SUGAP SUGAP TEXAS	PLANNING & ZONING COMMISSION AGENDA REQUEST		
AGENDA OF:	1/8/08	AGENDA REQUEST NO:	VIF
INITIATED BY:	TRAVIS TANNER, AICP, SENIOR PLANNER	RESPONSIBLE DEPARTMENT:	PLANNING
PRESENTED BY:	TRAVIS TANNER	ASSISTANT PLANNING DIRECTOR:	DOUGLAS P. SCHOMBURG, AICP
		ADDITIONAL DEPARTMENT. HEAD (S):	N/A
SUBJECT / PROCEEDING:	VINTAGE TRAIL AT RIVERSTONE – PRELIMINARY PLAT CONSIDERATION AND ACTION		
EXHIBITS:	VICINITY MAP, RIVERSTONE GENERAL PLAN, PROPOSED PRELIMINARY PLAT		
CLEARANCES			APPROVAL
LEGAL:	N/A	DIRECTOR OF PLANNING:	SABINE SOMERS-KUENZEL,

This is the Preliminary Plat for Vintage Trail at Riverstone. It is part of the first series of plats in the Riverstone development in the City of Sugar Land's extraterritorial jurisdiction (ETJ). The proposed plat consists of approximately 29.7 acres and 53 residential lots. It is located in the southern portion of Riverstone (immediately north of Sanders Glen), in MUD 128 and in LID 15. L.J. Parkway will provide primary access to this subdivision.

2003 Approved Riverstone General Plan:

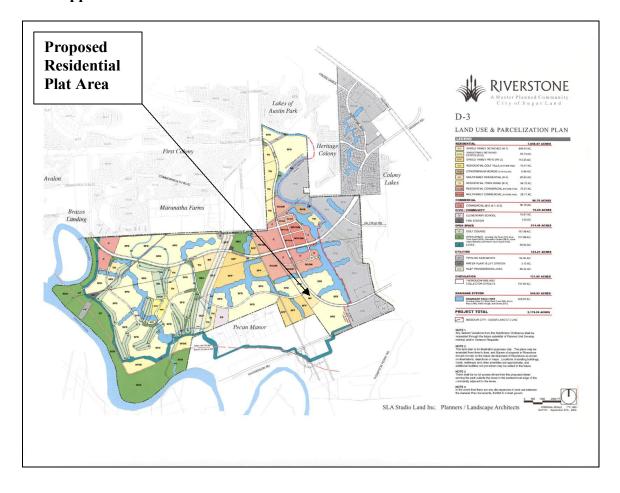
The General Plan for Riverstone was approved in 2003. The General Plan appears to indicate a combination of both multi-family and single-family residential as the proposed use for this location. The plat is proposing single-family residential lots, which is a less intense use. Compliance with the General Plan is not as exact as the Commission normally sees. For example, in Telfair, the outline and location of streets and sections of plats can be directly shown on the approved Telfair General Plan. There has been some discussion between the

developer and Planning staff of the extent to which this plat, and the two other preliminary plats on the January 8 agenda, must follow the General Plan. However, we've recognized that the determination ultimately is up to the Commission. According to the developer, an amendment to the General Plan is forthcoming, but in the interest of time and his need to respond to market demand, he has requested these three plats be approved. That amendment will reportedly more accurately reflect the layout of this plat as well as that of the other two plats on the agenda.
